PROJECT: NEW ADMINISTRATIVE BUILDING FOR THE NATIONAL ASSEMBLY OF CAMBODIA

WORK PACKAGE: MAIN CONTRACT WORK

SUBJECT: CLARIFICATION OF BIDDING DOCUMENTS NO.07

CLARIFICATION OF BIDDING DOCUMENTS NO. 07

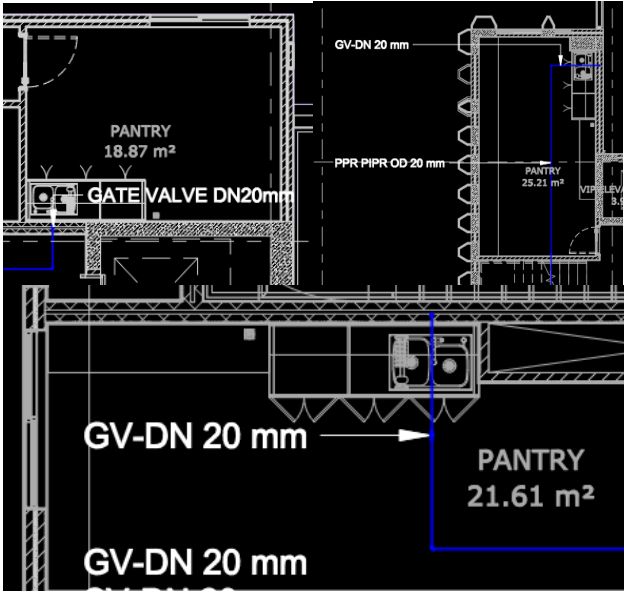
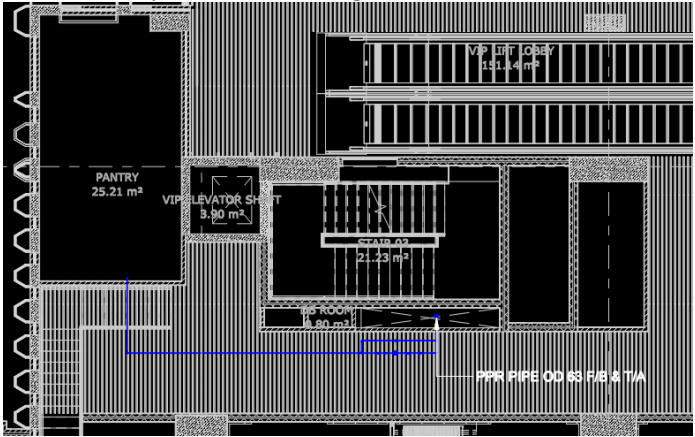
33	<p>There is an underground pipe & a concrete manhole shown in the tender drawing: Sheet No: ME-NA-EP-1001 please clarify as follows:</p> <p>a). Incoming 22KV cable from MV metering: Supply and install cable by contractor or by other?</p>	<p>a). By Contractor.</p> <p>b). By Contractor.</p>

<p>b). Underground pipe & manhole works: Supply and Install by contractor or by other?</p> <p>c). If it is under contractor's scope of works, please provide the drawing location and cable routing layout.</p> 	<p>c). Yes, please see the attached dwg layout. No. ME-NA-EP-1001. The location of existing MV substation including pipe routing are indicative. Provide cost provision for the site survey of underground services including adjustment if necessary.</p> <p>d) Drawing no. ME-NA-EP-1001 also include the interconnections from existing NAB Control /Server Room to New NAB Security Control (Server) Room.</p>
<p>34</p>	<p>Base on drawing tender: Sheet No: ME-NA-EP-1001: please clarify the following:</p> <p>a). Generator set requirement is Open type? yes or no.</p> <p>b). Intake air with soundproof? Yes or no.</p> <p>c). Outlet air with soundproof? Yes or no.</p> <p>d). Wall acoustic with soundproof? Yes or no.</p> 	<p>a). Yes. (Already mentioned in the drawing layout and single line diagram)</p> <p>b). Yes.</p> <p>c). Yes.</p> <p>d). Yes.</p>

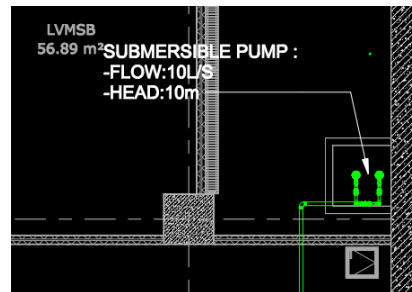
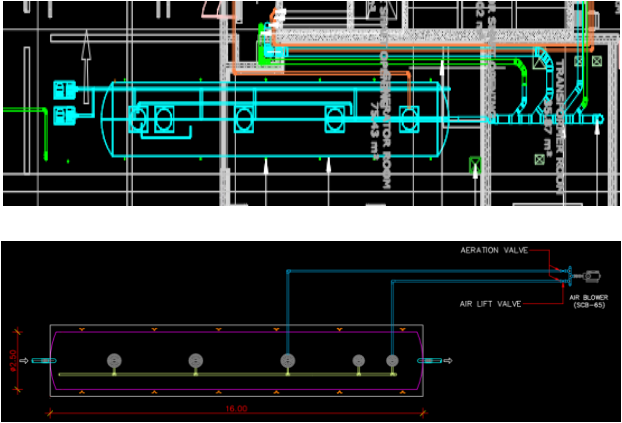
Please refer to schematic ME-NA-WW-6001 & drawing layout ME-NA-WW-1101, there are different capacities of submersible pump 01 to 06 as per the snapshots below:

- Please clarify which one should be selected?

Capacity = 15.9m3/h and 15m head. (Refer to previous RFI reply)

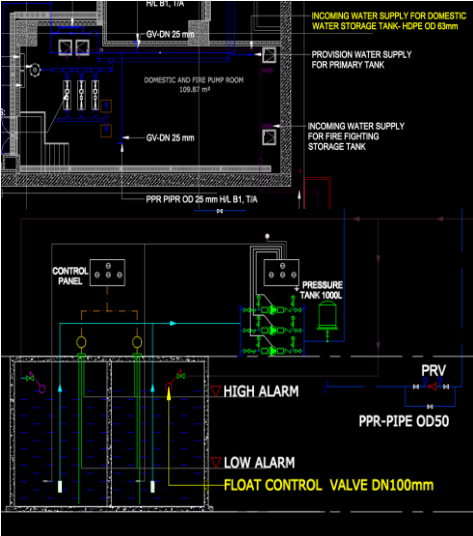
Please refer to schematic ME-NA-WW-6001 & drawing layout ME-NA-WW-1102, there are different capacities and head loss of submersible pumps. Please clarify which one should be selected?

Follow layout plan Flow: 10l/s and head: 10m

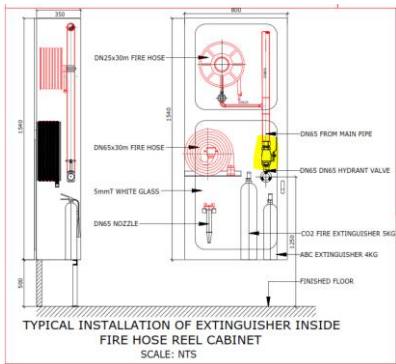
69 Refer to 0833 sprinkler & ME-NA-FF-0101 did not indicate about Temperature rating, K factor and response type of upright and pendant sprinkler head. Kindly provide to us.

K5.6 ,temperature 68 °C.

Drawing no. ME-NA-FF-6001, schematic diagram

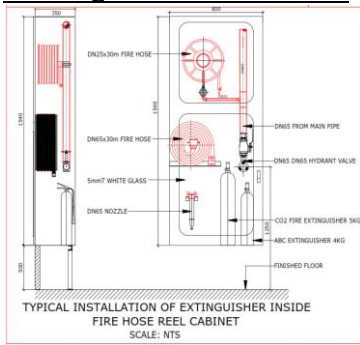
Refer to BOQ format Bill No.15 Fire Protection in the hose reel cabinet, it includes 1set: hose reel drum DN25 x30m with nozzle, and 1 set: Fire extinguisher ABC and CO2 type BUT in the drawing no. ME-NA-FF-5001, ME-NA-FF-6001 and spec 0832-Stand pipe and Hose, it indicates 1set: hose reel drum DN25 x30m with nozzle, 1set: Fire extinguisher ABC and CO2 type, and 1set: lay flat hose DN65x30m c/w Angle valve hose and ball valve. Please clarify the following:

- 1-Should we follow the BOQ or the Drawings and Specifications.
- 2-If we follow drawings and specifications, please confirm the hose rack (hose lay flat) diameter and landing valve size.

1. Follow Drawing
2. Size as shown in drawing ME-NA_FF_5001

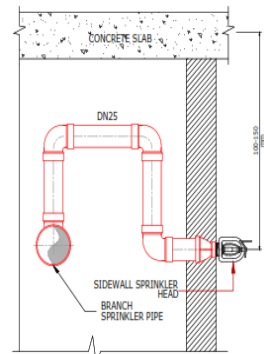
Fire hydrant set should be outside type, but in the BOQ indicates indoor type. Please clarify.

6	Fire Hydrant Set (Indoor Type): - Self-stand Cabinet Size: H1600mm x W560mm x D300mm - Fire Hose Layflat DN65 with Nozzle (2Units)	Unique	Set	2.00
---	---	--------	-----	------

Use Outdoor type.

TYPICAL SIDEWALL SPRINKLER HEAD INSTALLATION

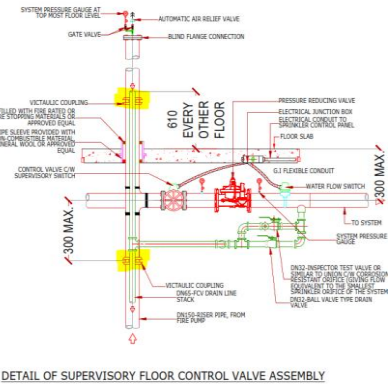
Refer to drawing no. ME-NA-FF-5001:
1- Please confirm if side wall sprinkler head will be used, and also the drawing layout.
2- Please indicate the temperate rating, K factor and response type.

Not used

DWG: ME-NA-FF-5002

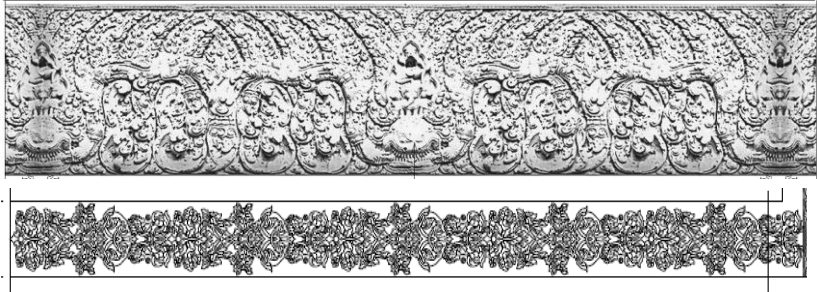
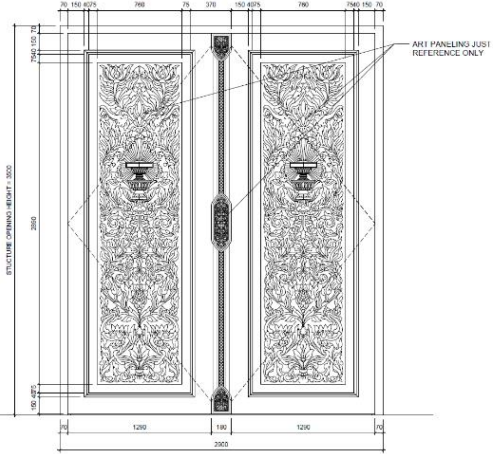
There is a discrepancy between layout drawing of fire pump room (DWG:ME-NA-FF-5002) and specification: 0834 Fire Pumps. In the drawing, Fire pumps use split-case type. But in the specification is vertical in-line pumps, Horizontal base mounted pumps, and Vertical Turbine pumps. Please clarify what type of pump should be used for main electrical fire pumps, main diesel fire pumps, and jockey fire pumps.

Please follow drawing.

ESCALATOR WORK

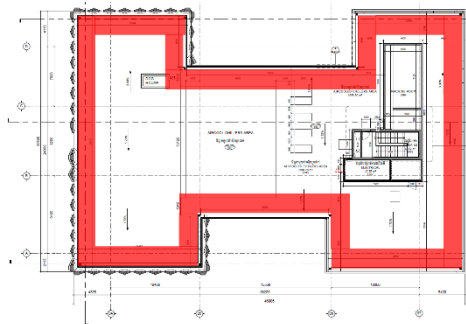
Please provide the detailed drawings of lateral & bottom cladding (material, framing, etc) of the escalators.

For the material of the cladding is stainless steel hairline.
